**TOWN OF NEWBURGH
PLANNING BOARD
TECHNICAL REVIEW COMMENTS**

PROJECT: COLANDREA SUNSHINE FORD LINCOLN
PROJECT NO.: 15-24
PROJECT LOCATION: SECTION 99, BLOCK 4, LOT 23.2
SECTION 99, BLOCK 1, LOT 17.2 (FORMERLY)
SECTION 99, BLOCK 4, LOT 1 (FORMERLY)
REVIEW DATE: 5 JULY 2016
MEETING DATE: 7 JULY 2016
PROJECT REPRESENTATIVE: SHAW ENGINEERING

Re: Addition To Colandrea Ford-Lincoln
40 NYS Route 17K

PARTIAL UTILITY PLAN
SCALE 1"=20'

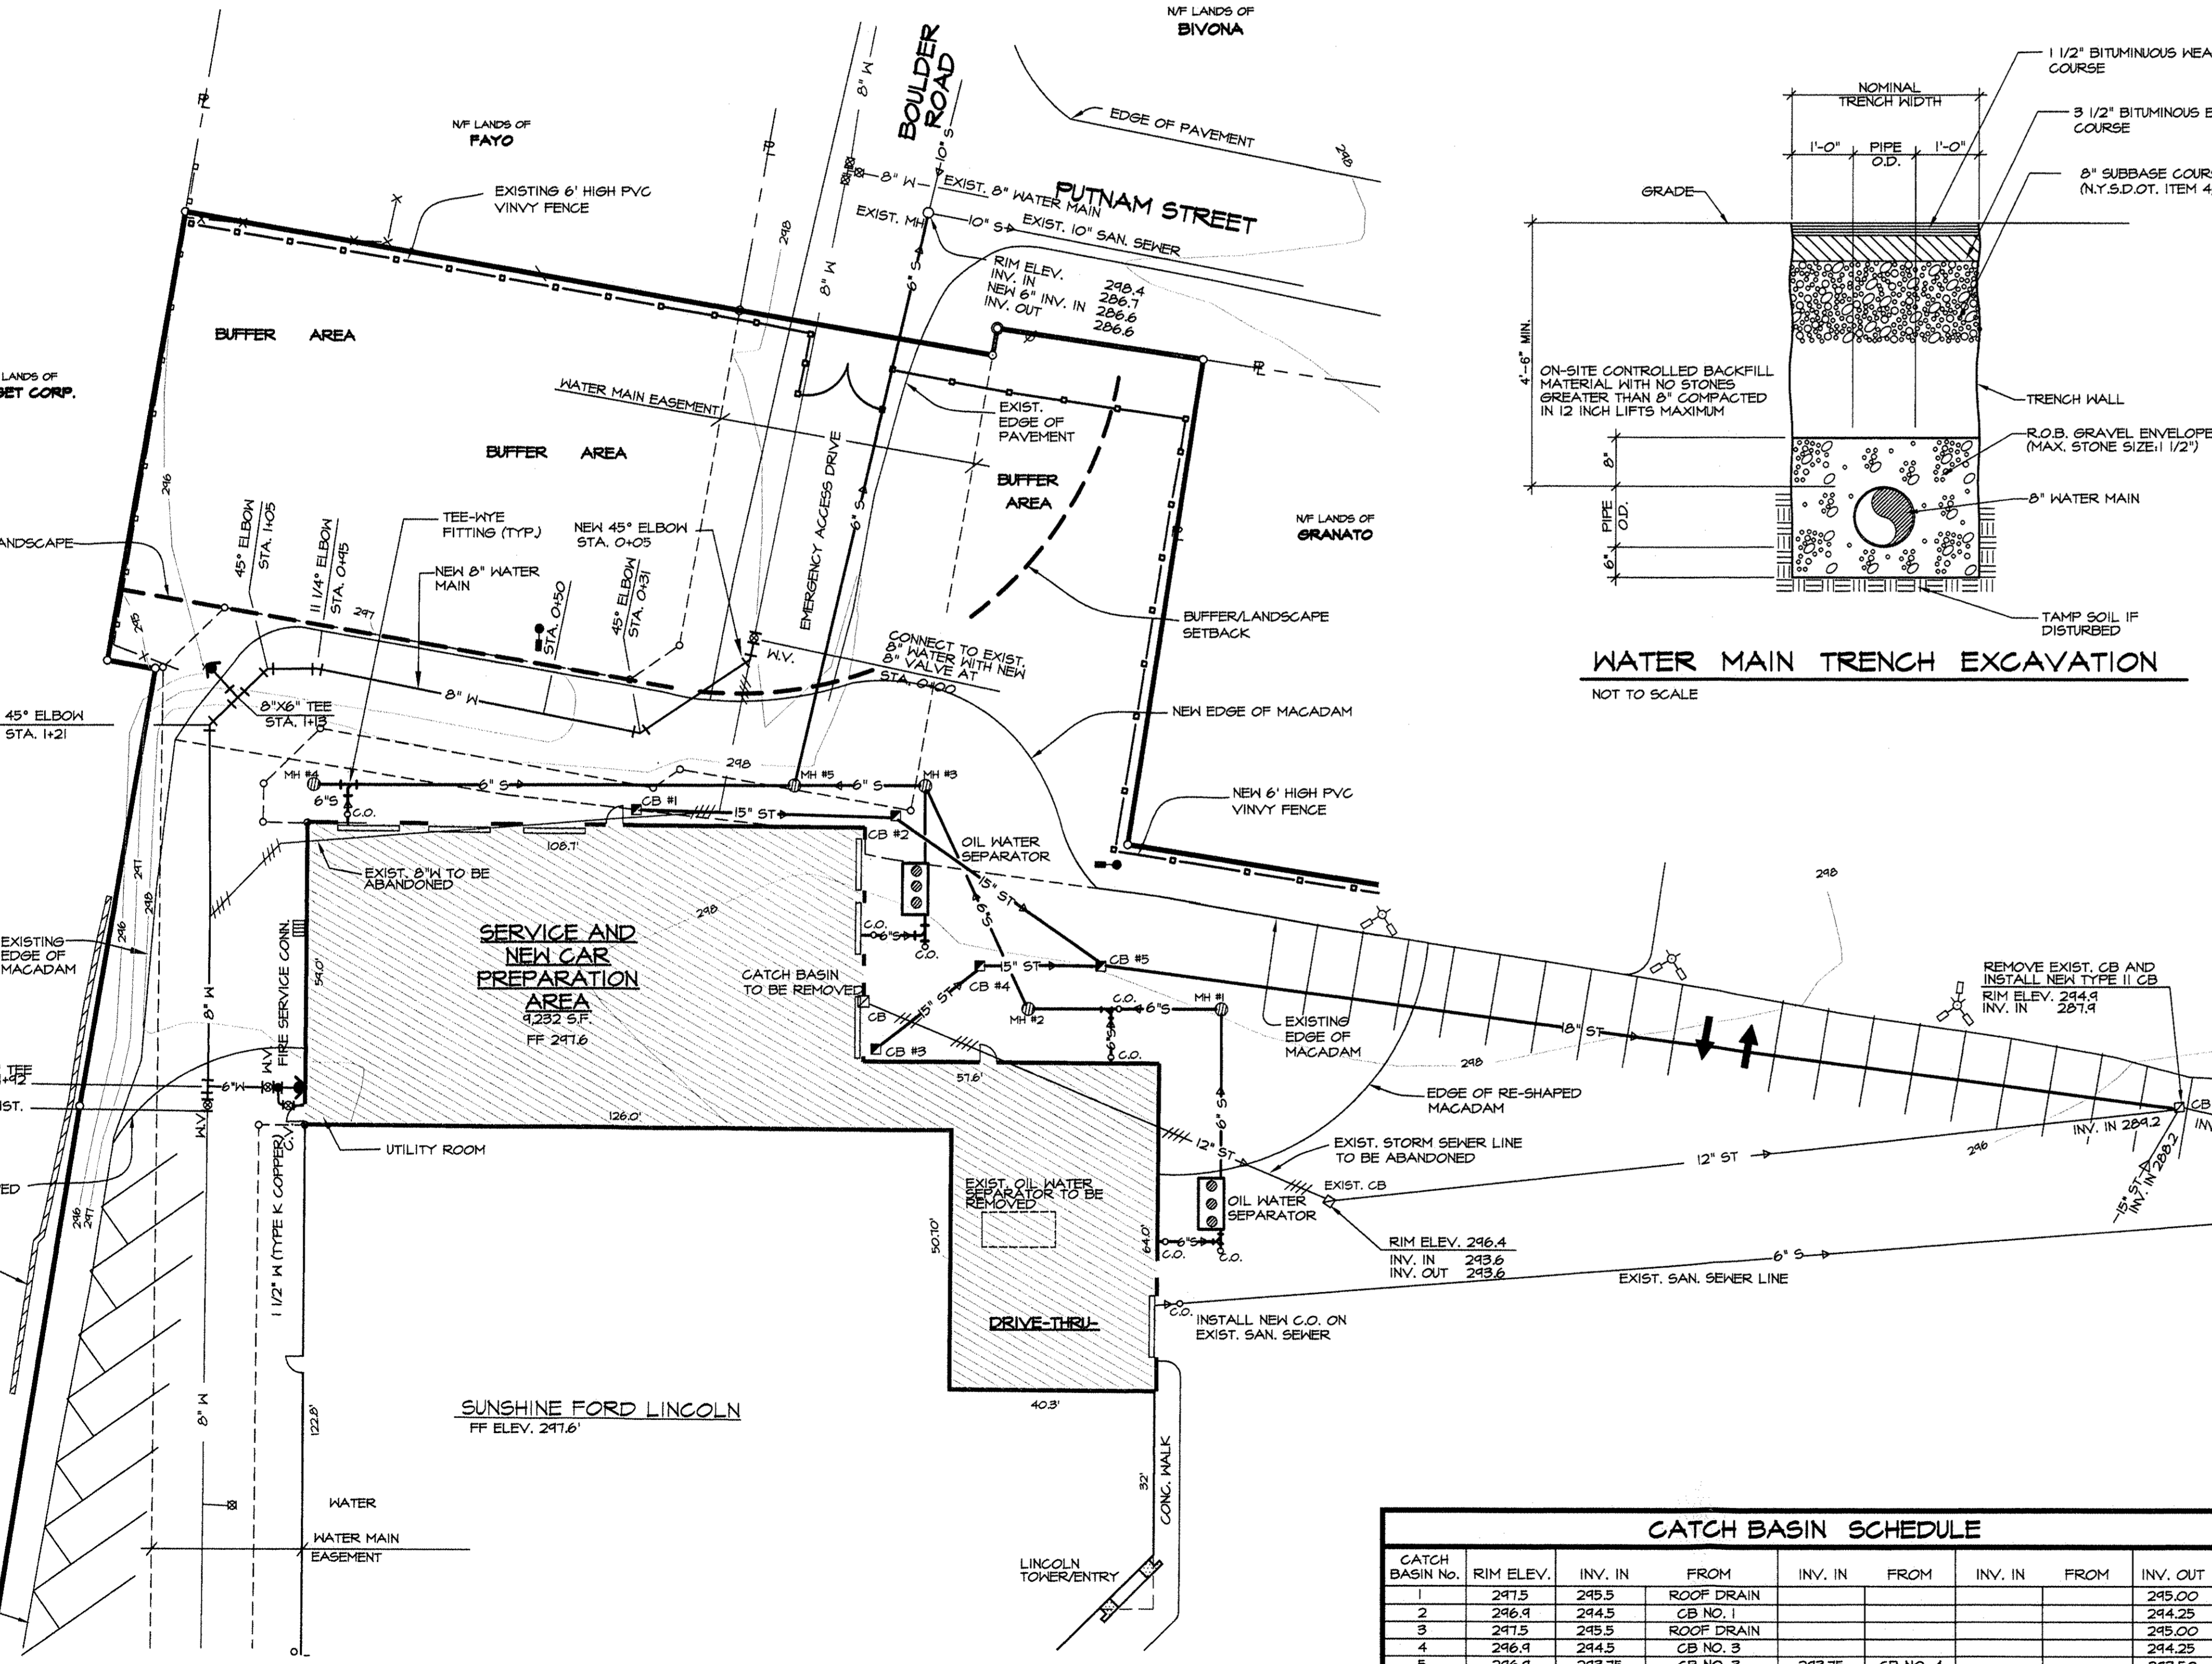
5. The project proposes the relocation of a water main which loops through the site. Approval from Town Engineer and Water Department should be received.

LIGHTING PLAN
NOT TO SCALE

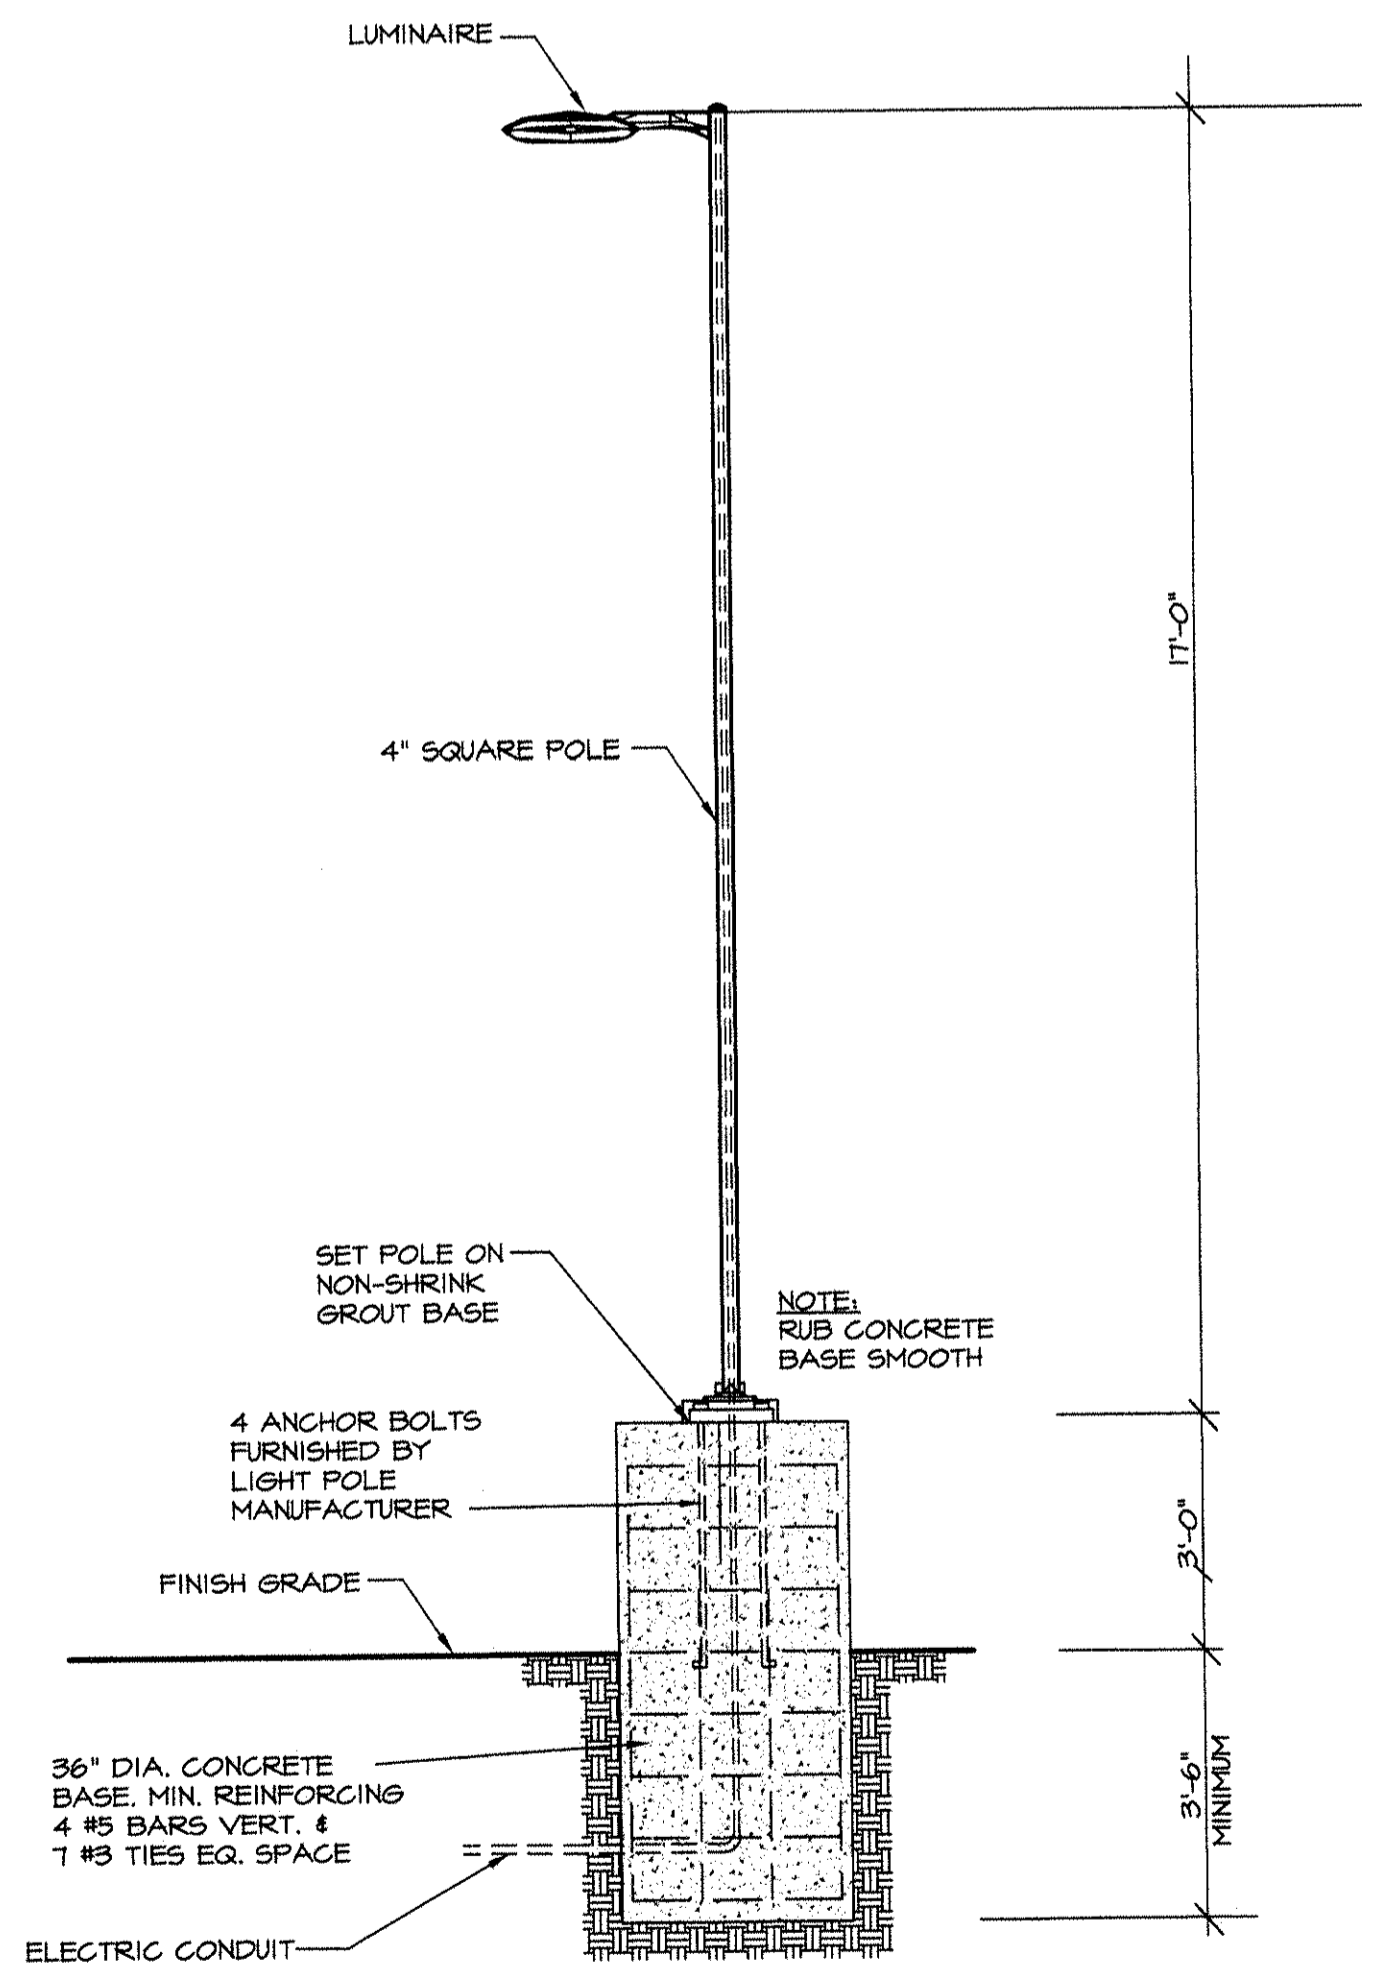
8. A lighting plan has been identified depicting foot candles. A 20 foot high light pole is proposed.

5. This Referral to Orange County Planning will be done by the Planning Board.
6. No comment as it is Mike Donnelly's determination.
- 7, 8 & 9 Site Details, a Lighting Plan and a Landscaping Plan have been added to the drawings
